CITY OF DULUTH
Planning Division

STAFF REPORT

PL 13-167

Shoreland Variance
302 Ridgewood Road

SHEET NAME:
PROPOSED
SITE PLAN
SHEET #:
PD2

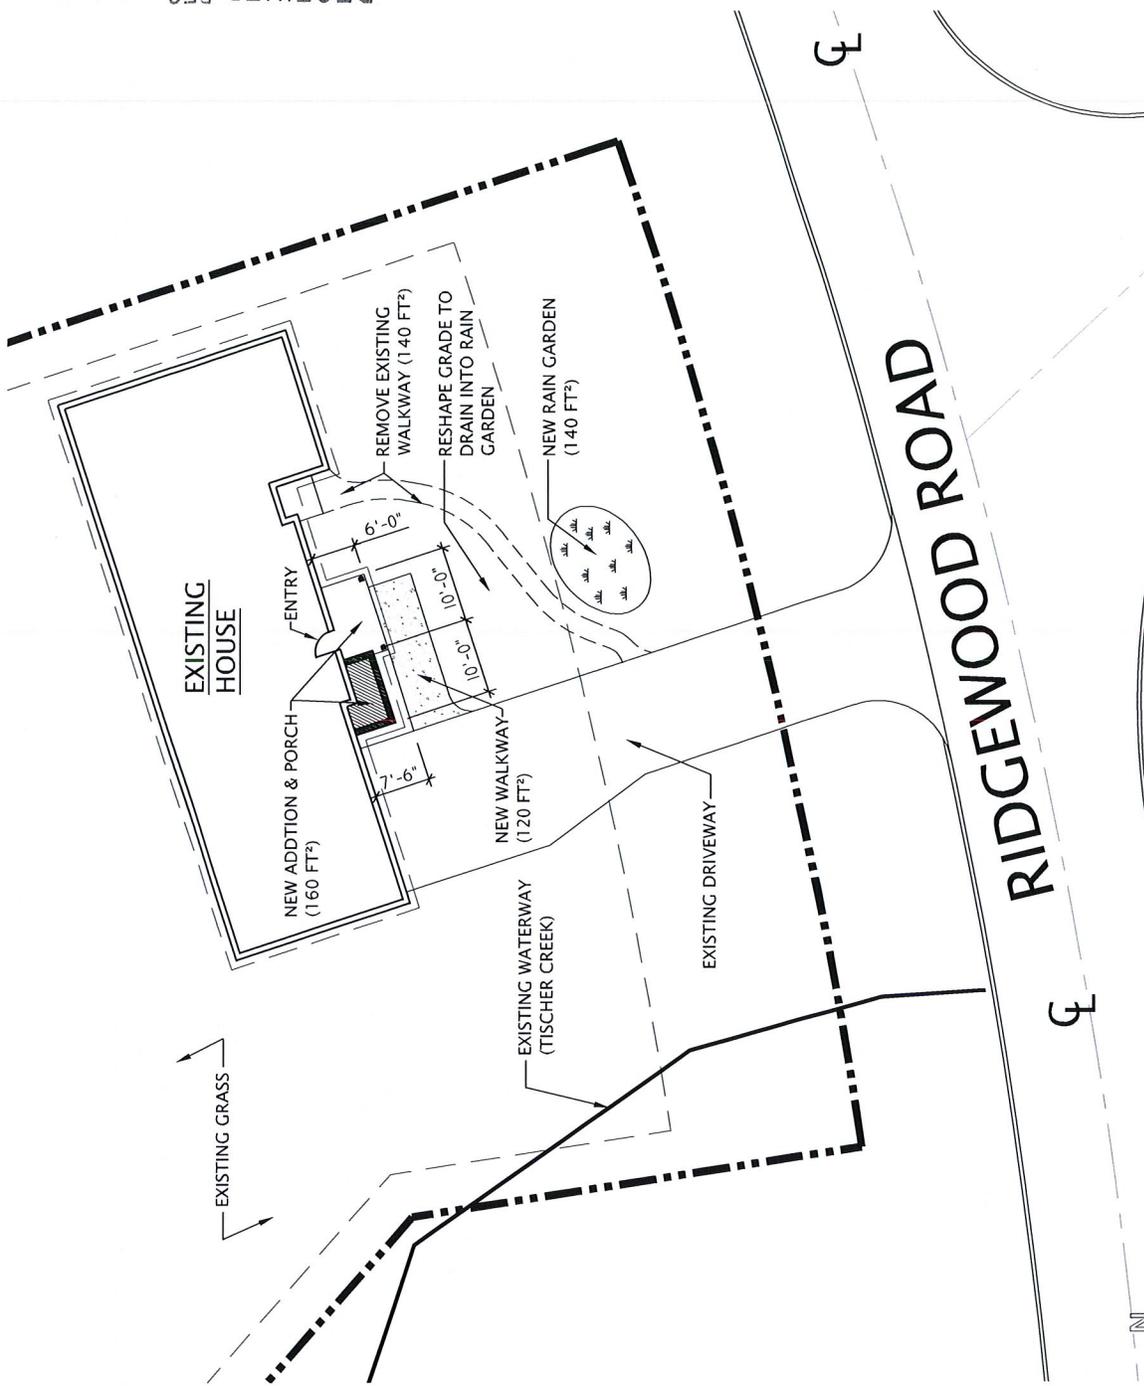
- 1) The applicant is requesting a variance to add a small addition (90 sq ft porch and 70 sq ft entry addition) to the existing single family home. The proposed addition is within the Coldwater River shoreland setback. The existing home is approximately 35 feet from the creek, and the proposed expansion will be about 60 feet from the creek. The structure setback for a Coldwater River is 150 feet; nearly the entire lot is within the 150 shoreland setback.

- 3) The applicant is proposing the addition to provide more adequate space and improve the entry to the home. The applicant is also proposing to relocate the existing walkway (remove 140 sq ft and install 120 sq ft of new impervious surface, for a net reduction of 20 sq ft). The applicant will install a rain garden in the front yard to mitigate potential impacts. The applicant has also planted approximately 80 trees along the creek as part of the Duluth Stream Corps project.

- 5) The applicant currently has a reasonable use of their property with the existing single family home. While the proposed addition would be a benefit to the applicant and make the home more functional/enjoyable, that fact by itself does not constitute a hardship or practical difficulty. If the variance was denied, it would not deprive the property owner of a substantial property right.

- 6) The lot does not have wetland, slope, bedrock, or other topographical conditions that present a practical difficulty to the use or enjoyment of the property. The applicant does not have a practical difficulty that would require a variance to enjoy the existing structure.

Based on the above findings, Staff finds that the requested variance does not meet the criteria established in 50-37.9 and that the applicant currently has a reasonable use of the property without the need of a variance. The application does not meet the standards for a variance and therefore staff recommends denial.
